# Zoning Staff Report

**Case Number:** ZC-23-092

## Zoning Map Amendment & Site Plan

**Site Location:** 2401 S. University Drive

PLANNED DEVELOPMENT SITE  
PLAN

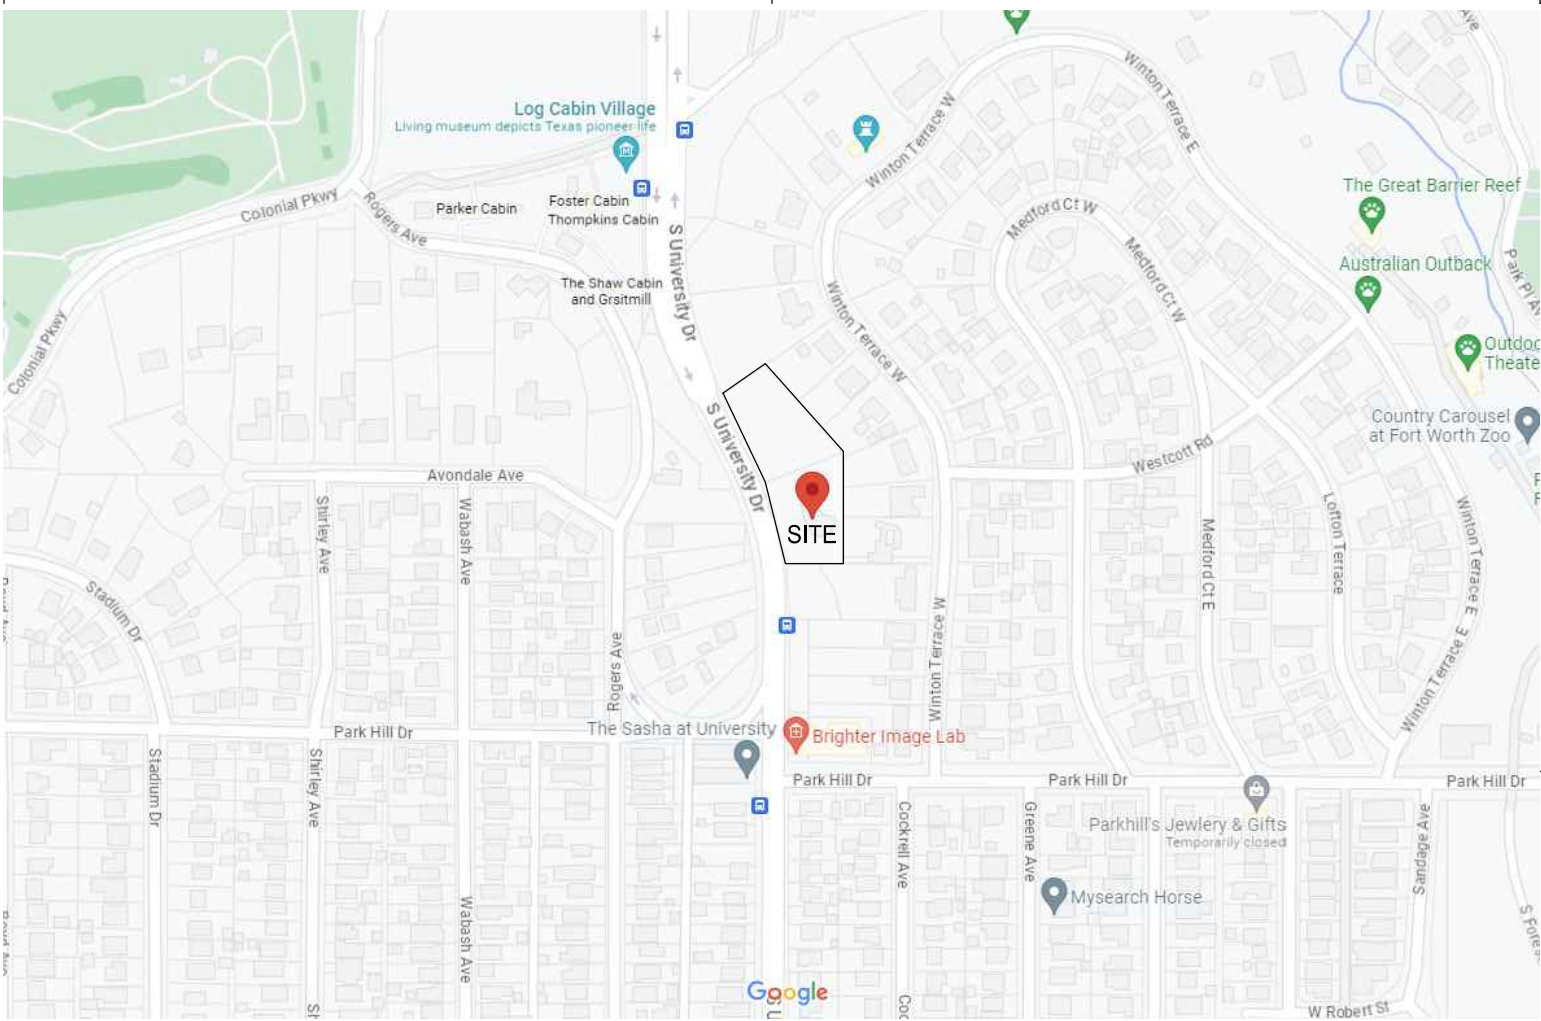
- State Law prevents a municipality from regulating exterior materials through zoning. These are now regulated through the building Code. You can remove the waiver request from application [Will do](#)

- Waiver Exhibit for PD-E section should have title section reading “Planned Development for all uses in "E" Neighborhood Commercial, excluding the following uses: [Will do. We are having additional discussions on this point with the Park Hill residents and may continue to add further excluded uses.](#)

- On Site Plan, depict and label any existing easements on the property [Will do](#)
- Remove the trees being preserved and show on separate exhibit [Will do](#)

- FYI - Areas directly abutting single family zoning along the north, east, south require a supplemental setback of 3:1 based on height [minimum 30 feet], plus 1:1 for garages carports, as well as a 5 foot landscaped buffer and 6 foot high solid screening fence. Ensure you meet these requirements or they will need to be addressed in the waiver requests [We will produce these diagrams for the zoning hearing. Because of the existing topography our building site is between 20 and 40 feet below the adjacent homes, so we're not expecting this to be an issue](#)

- Add case reference ZC-23-092 to site plan [Will do](#)
- Add Site Data Table to site plan - include 3 columns – one with Site Data, second with “E” base requirements, and third with proposed “PD-ER” requirements. Any areas that do not meet the minimum will need to be marked with “Waiver Requested” [Will do](#)

- Show location of dumpster on site. It cannot be located in any required front yard nor can it be located between the front face of the building and the street [Will do. We are negotiation with the adjacent](#)

- Will require sidewalks along University frontage, please add to Site Plan [Sidewalks already exist along University for the entire length of the site.](#)

- Please add Supplemental setback, landscape buffer, and screening requirements to Site Data Table on Site Plan, with the following standards under the "E" column (from table in Section 4.910 of the Zoning Ordinance). [Will do.](#)

commercial center to share their dumpster thinking that a single dumpster will be less disturbance to the neighbors, but we'll show a planned location just in case.
